Sixty-eighth session

Proposal of amendments to the ATP: Pending proposals

Interpretation of external surface area measurement for panel vans

Transmitted by the United Kingdom

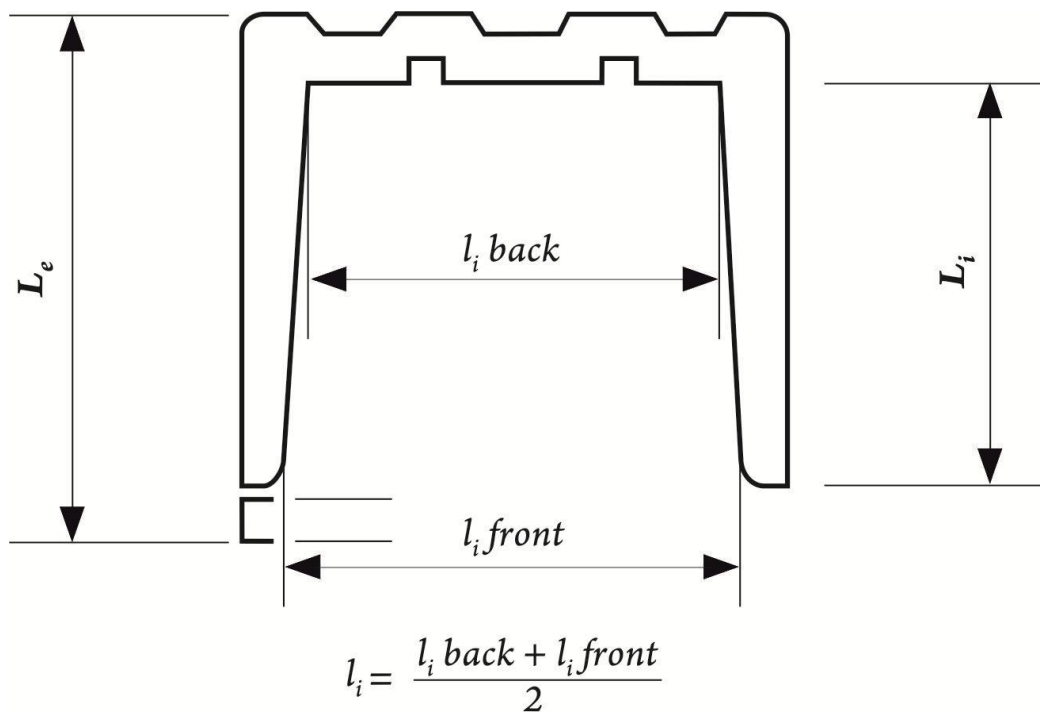
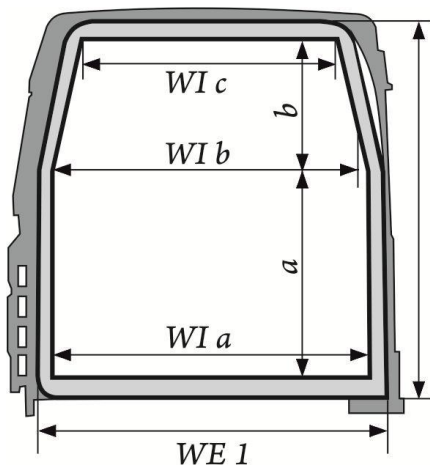
3. Measurement of the external surfaces of a van cannot account for unfilled voids within the structure. Panel voids might also include steel structures that bridge the external heat to the outer edge of the insulated wall panels.

4. The point is illustrated in the diagram below. The grey shading represents the main insulated panel and the black voids represent varying thicknesses of foam infill. The question is whether the external surface should be considered as the outer edge of the grey part or should it include the voids and be loosely considered as the external metal surface.

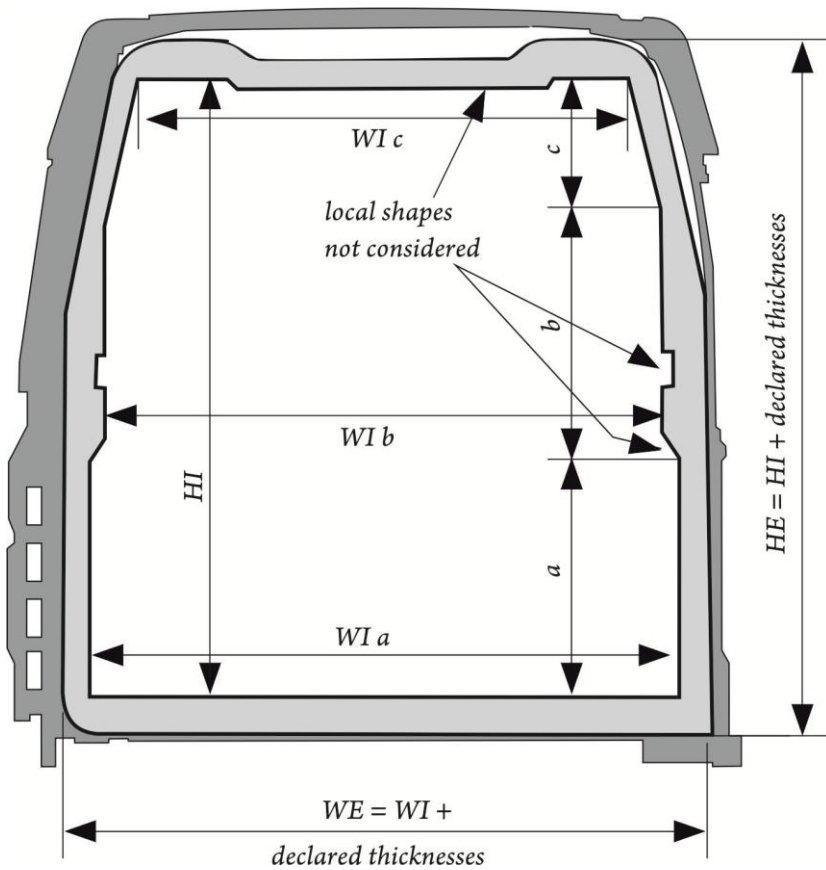
6. For the purpose of measuring the external and internal area it is proposed to use the method developed by project committee 413 for TC113. The method uses a manufacturer declared thickness of insulation material with a check calculation.

$$WI = \frac{WIa \times \frac{a}{2} + WIb \left(\frac{a}{2} + \frac{b}{2} \right) + WIc \left(\frac{b}{2} \right)}{a + b}$$

(to be discussed)

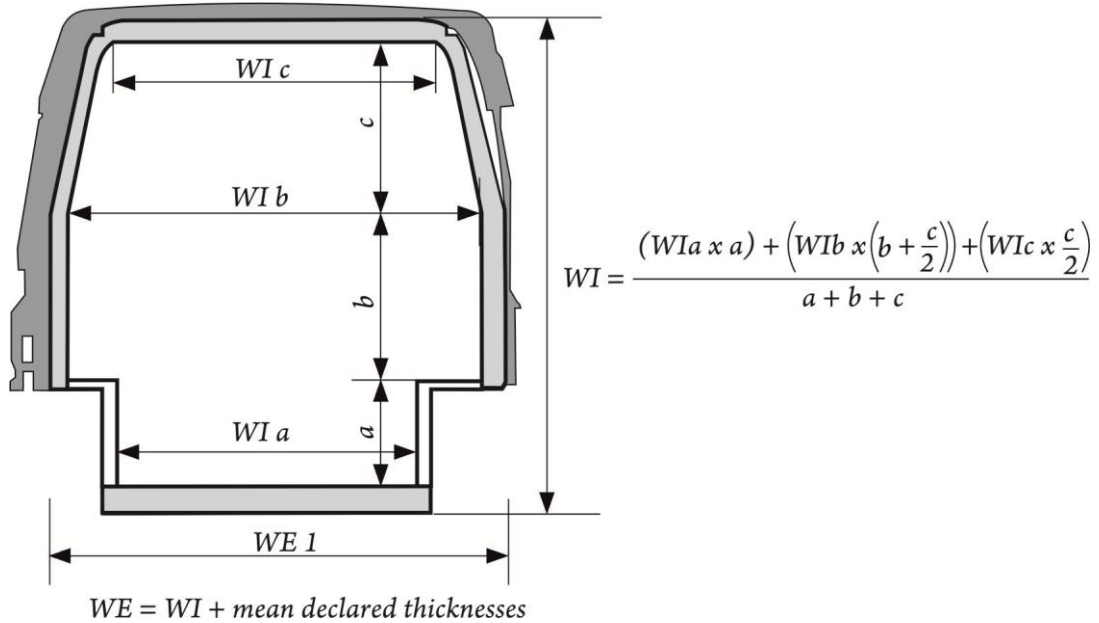
$$WI = \frac{WIa \times a + WIb \times \left(b + \frac{c}{2} \right) + WIc \times \frac{c}{2}}{a + b + c}$$

Mean declared thicknesses (mm) $< \frac{25}{K}$

(to be discussed)

7. The following text should be added to annex 1, appendix 2, paragraph 1.2 as follows:

“For insulated panel vans the external surface area should be considered as the inner dimensions plus the declared thickness of the insulation material. Localised shapes are not considered and the wheel arches are subtracted from the final calculation.

$$WI = \frac{(WIa \times a) + (WIb \times (b + \frac{c}{2})) + (WIc \times \frac{c}{2})}{a + b + c}$$

$WE = WI + \text{mean declared thicknesses}$
